DEVELOPMENT APPLICATION ASSESSMENT REPORT

Application Number:	DA2024/1348
----------------------------	-------------

Responsible Officer:	Thomas Burns
Land to be developed (Address):	Lot 6 DP 111254, 1142 Pittwater Road COLLAROY NSW 2097
Proposed Development:	Alterations and additions to a dwelling house
Zoning:	Warringah LEP2011 - Land zoned R2 Low Density Residential
Development Permissible:	Yes
Existing Use Rights:	No
Consent Authority:	Northern Beaches Council
Land and Environment Court Action:	No
Applicant:	Yan Honda Architects

Figure 1 - northern elevation envelope breaches highlighted in red

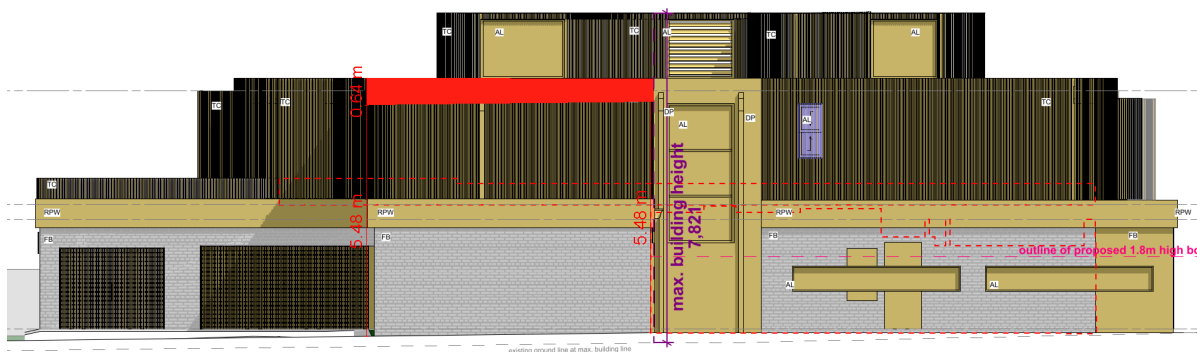
Section B3 of the WDCP requires buildings to remain within a side building envelope that is determined by projecting planes at 45 degrees from a height of 4m above the existing ground level at side boundaries.

The development includes partial encroachments outside of the side envelope requirement on the northern and southern elevations (refer to **Figures 1-2**).

Figure 2 - southern elevation envelope breach highlighted in red

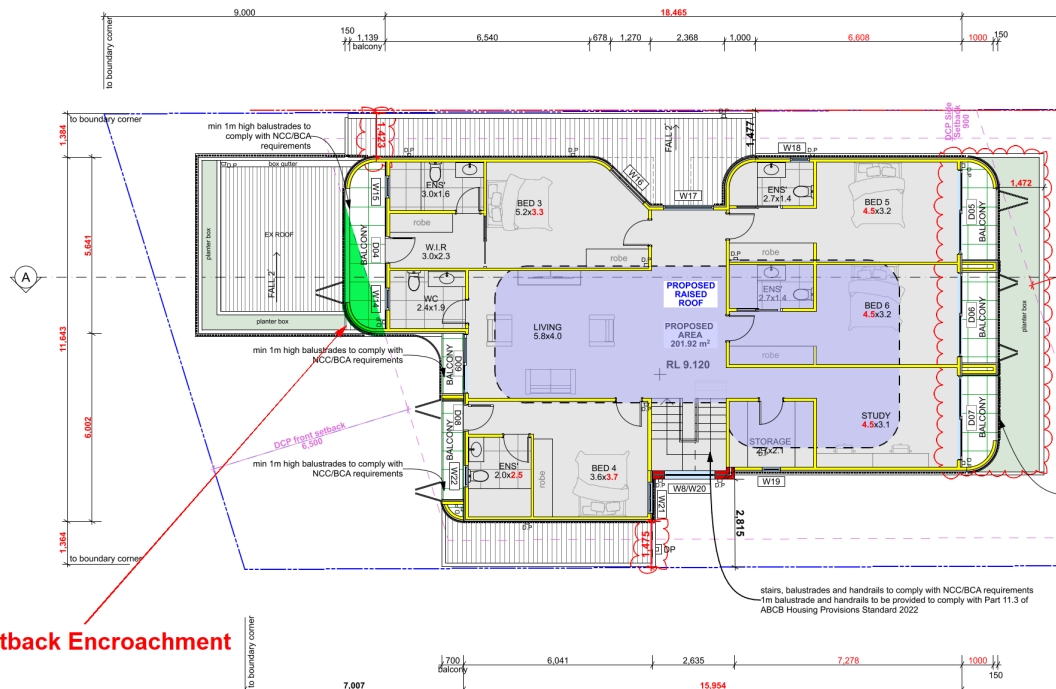
The site is generally flat and the development is considered to be an appropriate response to the site topography, insofar as the building steps in from the side elevations as the building height increases.

Figure 4 - aerial image to depict the Subject Site, 1140 Pittwater Road and Collaroy Beach

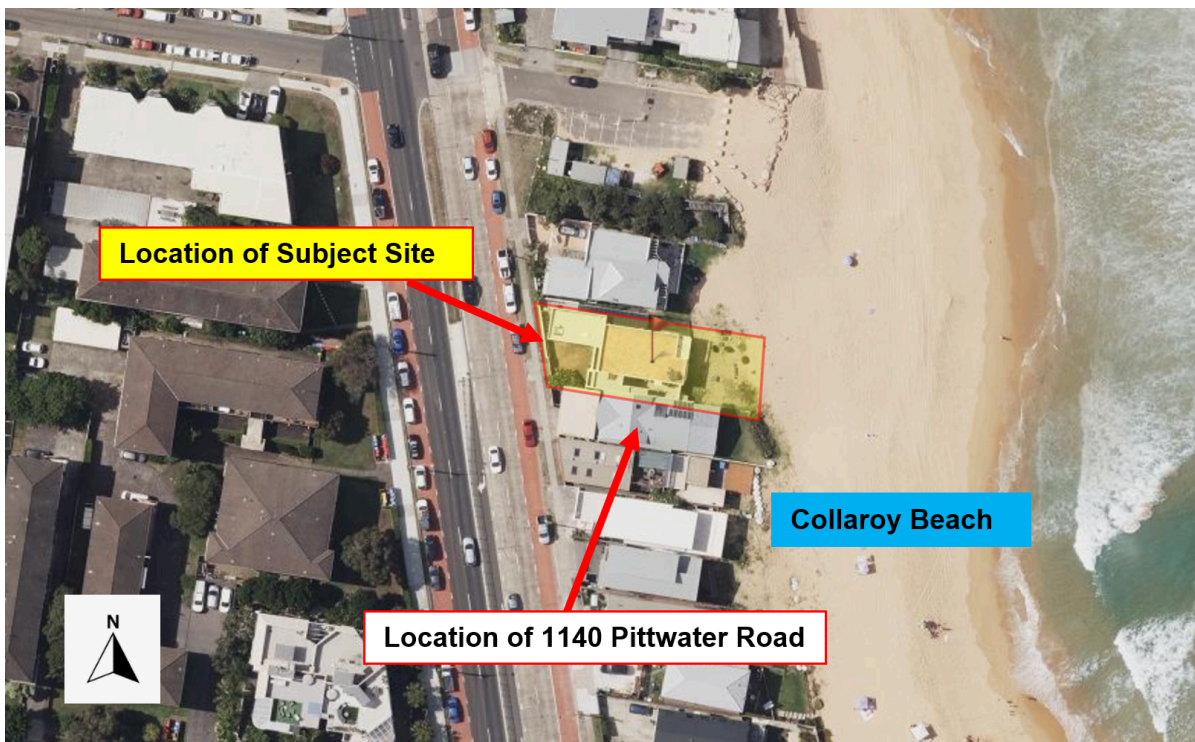
Accordingly, the assessment has considered view loss from the adjoining property. For the purpose of this view loss assessment, an inspection from the adjoining property was not deemed necessary, noting that the concerns only relate to the proposed boundary fencing. The site inspection at the subject site and the documentation submitted with the application is sufficient to conclude the extent of impacts from the adjoining property are acceptable.

Figure 4 depicts the subject site and southern adjoining property.

Figure 5 - retained view corridors

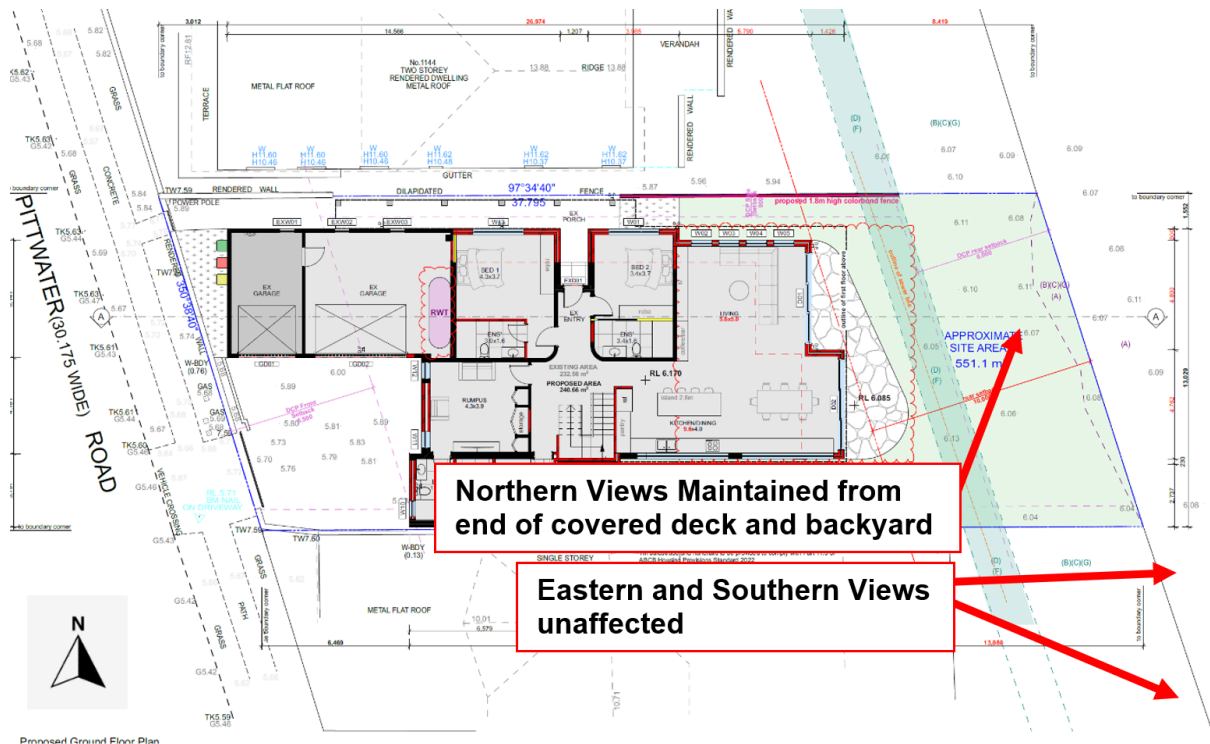
The proposed 1.8m side boundary fencing on the site would obstruct standing views from the internal living areas to the north. However, when standing or sitting at the end of the covered decking area (see **Figure 5**) or anywhere within the backyard, the northern views would be retained as the proposed side boundary fencing is setback approximately 9.5m from the rear boundary. All other views from the property would be retained.

In this regard, the qualitative extent of impact is deemed to be minor.

- The 1.8 metre high colourbond side boundary fencing must be replaced with a 1.8 metre high timber batten fence. The length of the fence must correlate with approved plans.
